**MICHIGAN DEPARTMENT OF NATURAL RESOURCES & ENVIRONMENT**

**INTEROFFICE COMMUNICATION**

**SUBJECT:** Comments on "Groundwater Issues, North Bronson Industrial Area Operable Unit 1, Bronson, Michigan," by Leo M. Brausch on Behalf of the Potentially Responsible Party (PRP) Group, dated January 27, 2010, Branch County Michigan

# Relocated and Added Geoprobe borings for Final Plume Delineation

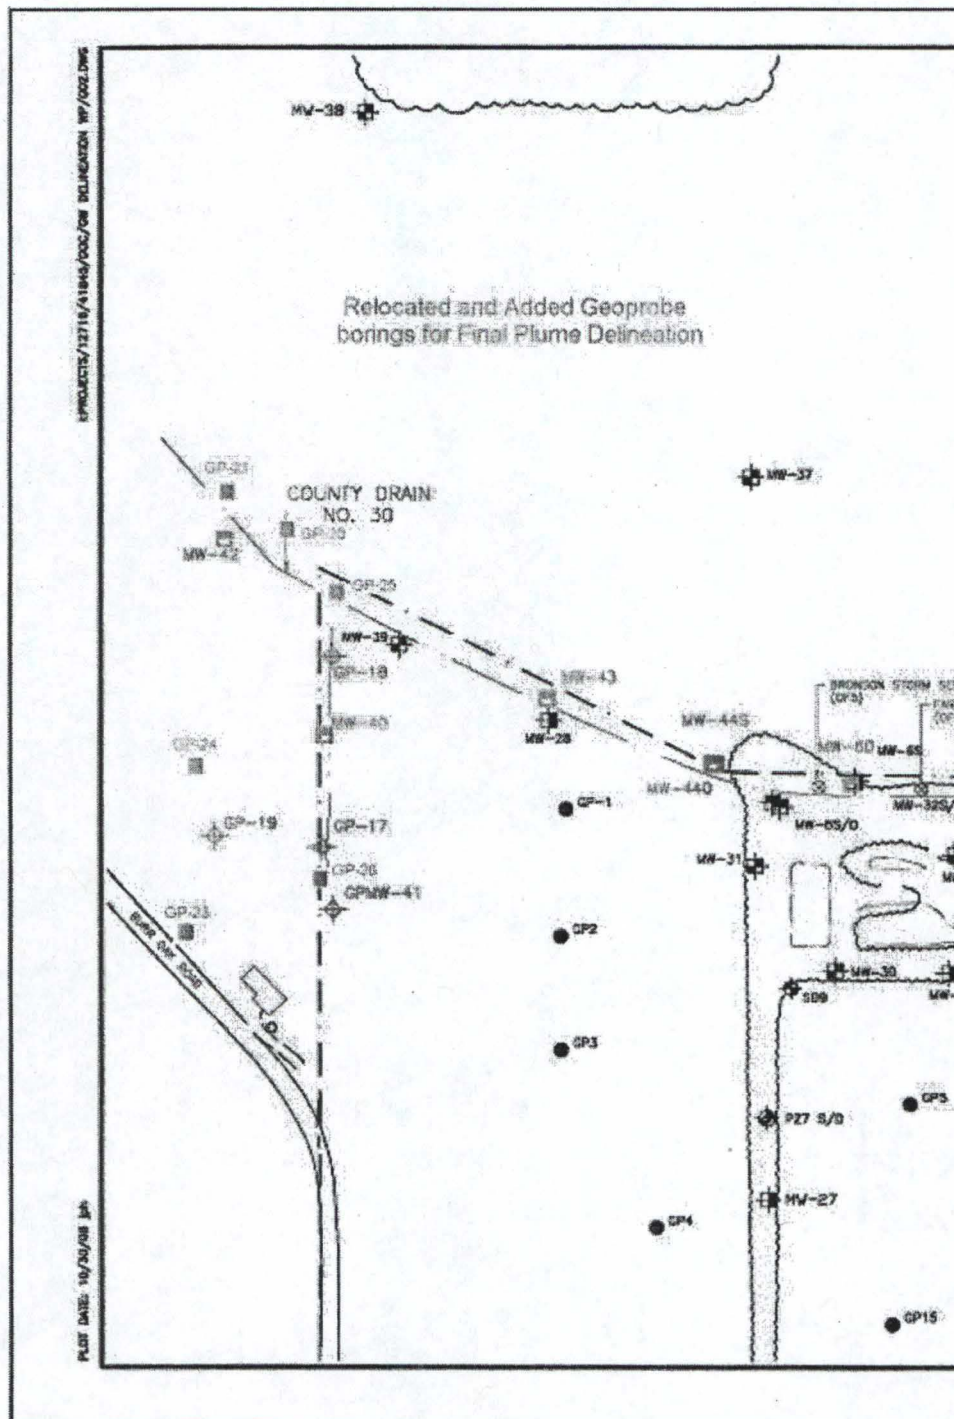
- GP-21: Perform this VAS boring across CD#30 from MW-42, instead of almost 100 feet to the northwest. This will move the boring/well closer to known groundwater impacts and provide some symmetry to MW-42 on the south side of the drain.

- GP-20: Move this boring due south to a location approximately 30 feet north of CD#30, southeast of newly relocated GP-21. No permanent monitoring well can be installed here due to ongoing agricultural activity, but the VAS and stratigraphic data will provide a better understanding of the potential contaminant migration along the north side of the drain. This boring location also conforms closer to the groundwater flow lines as depicted in recent potentiometric maps.

- GP-24: Move this boring approximately 225 feet southeast of its current location just northwest of the assumed plume boundary line as depicted on Figures 1 and 2. If contamination is present, depending on the concentration, another boring could be stepped out following the same irrigation piping route. It appears that permanent monitoring wells are acceptable along this piping route according to Table 1. The table indicates that installing a boring and subsequent monitoring well in the currently chosen location will "...confirm [the] western limit of impacts." As noted above, this objective cannot be met by the existing planned activity; the boring must be closer to the assumed plume boundary.

- GP-23: If we assume that the groundwater flow west of the WLA is either westerly or northwesterly, this location is too far to the north to provide a sentinel well between where we know the plume exists and the two residential homes on the western side of Burr Oak Road. Based on assumed groundwater flow directions, it would be prudent to relocate this boring/well farther to the southeast along the eastern side of Burr Oak Road.

- GP-25: A new boring/well between GP-21 and MW-43 near the edge of the estimated plume boundary; this boring, in combination with GP-20, should provide sufficient data on the plume boundary along the northern side of CD#30. A

monitoring well can be installed near the edge of the plume boundary and GP-21 could serve as a monitoring well just outside of the plume boundary.

- GP-26: A new monitoring well along a drainage ditch south of MW-40 near the borings GPMW-41 and GP-17 to evaluate groundwater flow direction and to provide data on plume migration; based on site conditions, it appears that installing a monitoring well in this area is feasible.
